**Regulation 25  
Town and Country Planning  
(Environmental Impact Assessment) Regulations 2017  
Request for Further Information**

**Noise & Vibration Impact Assessment for  
Proposed Sand & Gravel Quarry  
at**

**Land at Bow Farm  
Bow Lane  
Twyning  
Tewkesbury  
Gloucestershire**

**Report No.: R18.1004/Reg25/Add1/DRK**

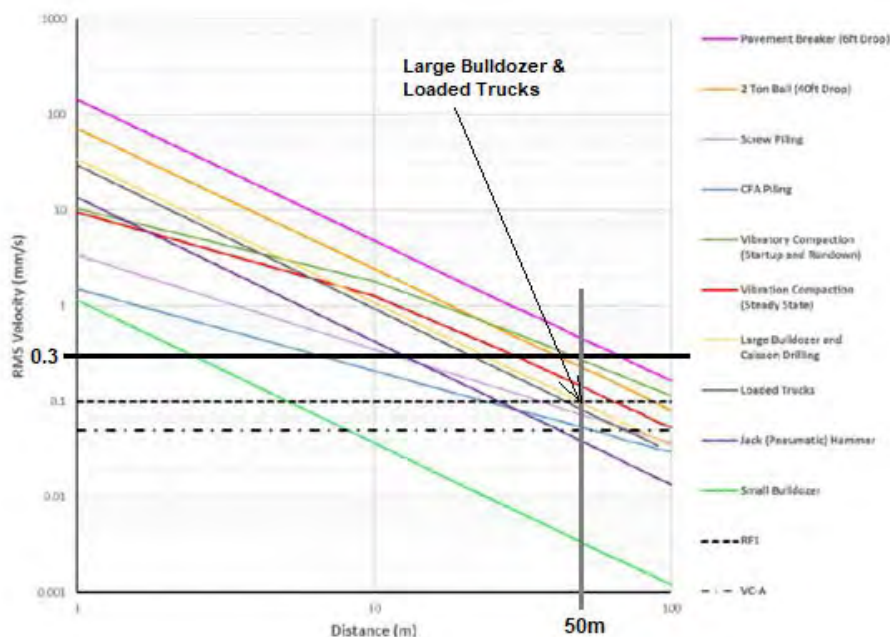
*The District Council notes that a further assessment has been submitted which assesses the vibration impacts upon sensitive receptors, in particular the Grade II Listed Puck Cottage. The main source of concern relating to the built designated and non-designated heritage assets is the lack of clear information about the impact of vibration on the structures over time.*

*The response to the Regulation 25 Request focusses on the perceptible vibration at a distance of 50 metres from the vibration source. It does not explain whether vibrations at a lower level, but over a long time could produce damaging effects on the structure of the buildings, in particular the Grade II listed Puck Cottage. Vibrations experienced by the timber-frame cottage at ground level could be amplified by the structure potentially causing structural movement. This possibility has not been clearly addressed by the application submission.*

*The reliance on perceptibility is considered to be potentially erroneous. The ground movements that cause subsidence are not perceptible, but their effects on a building are obvious. In the same way ground vibrations caused by operations and vehicles on the application site could cause movement effects on the heritage asset of Puck Cottage in particular. If this is not the case, then this needs to be addressed and explained. Consequently, there remains doubt about the level of impact that the proposal would have directly on the structure of the heritage asset, Puck Cottage, and indirectly on the asset’s setting.*

*In view of the above comments, the MPA requests further information assessing the impact of the proposal in terms of vibration impacts upon heritage assets, in particular the Grade II Listed Puck Cottage. This assessment should assess the potential long-term impacts of vibration upon heritage assets and risk of subsidence.”*

The graph showing typical vibration levels provided in the Regulation 25 response to a request for further information (NVC ref. R18.1004/Reg25/DRK dated 22<sup>nd</sup> July 2020) in response Q1 shows a maximum vibration PPV level of 0.1mm/sec. The graph is provided below for ease of reference.

The information presented in terms of empirical measured data and the case study provides clear evidence that the long-term effect on the Grade II Listed Puck Cottage or any other residential dwelling from vibration would be insignificant based on the type of plant that would be used at the site and separation distance for the following reasons:

The conclusion that there would be a **negligible impact** from vibratory sources used at the Proposed Development therefore remains correct and unchanged in our expert opinion.

**NOISE MAP 1: CONSTRUCTION OF EARTH MOUND SCREENING (NORTHEAST)**

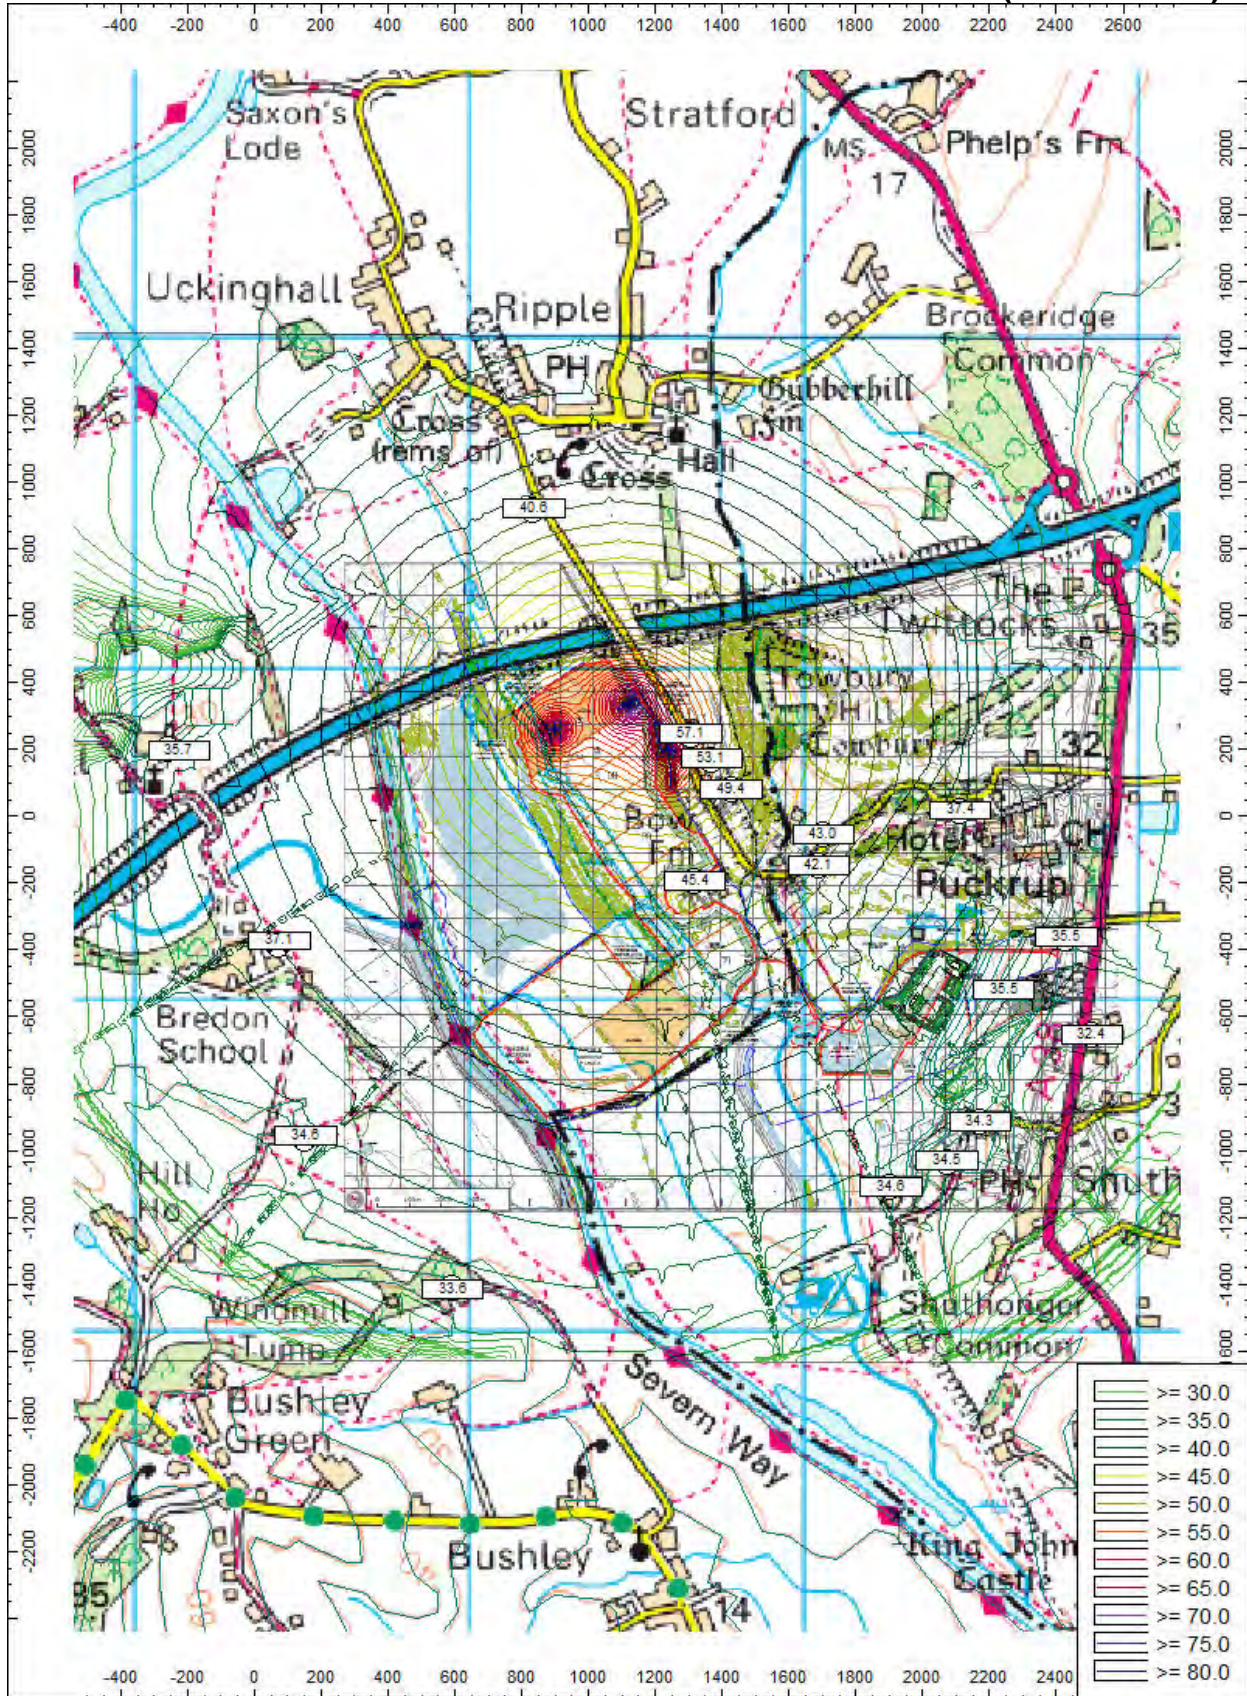
- i) Puck Cottage during temporary operations and extraction in phase 4 - where the operations are at the closest point not an average for the whole site during a typical phase as appears to be presented.*
- ii) Puckrup Hall Hotel at the edge of the golf course closest to the concrete batching plant whilst the latter is in operation in addition to the other process plant - with simultaneously a loaded HGV passing by up the gradient of the hill' plus Phase 9 extraction and any Flexible working A etc. Not a value at the hotel complex buildings.*
- iii) As above at the north western boundary of Church End Nurseries. None of these situations are included in the analysis when the data presented is closely scrutinised - only an unrealistic best case is presented.*

- (i) In terms of the properties off Bow Lane to the northeast boundary of the Site we have undertaken calculations of the nearest receptor point to the activity and as such would not execute noise modelling for every scenario during the life of the development. We expect therefore that the predictions cover the highest likely impact. In terms of predicted noise levels at Puck Cottage, we have re-checked the calculations for the initial temporary operations and phase 4 with the mobile plant at the closest approach to the property. The results show a level of 57dB  $L_{Aeq,1hr}$  for the temporary operations and 48dB  $L_{Aeq,1hr}$ . The cumulative effect of the extraction works and processing works shows a level of 49dB  $L_{Aeq,1hr}$ . The results are identical to the previous assessment noise models and therefore the assessment is robust.

Refer to noise maps 1 to 3 attached in Appendix NVC/1.
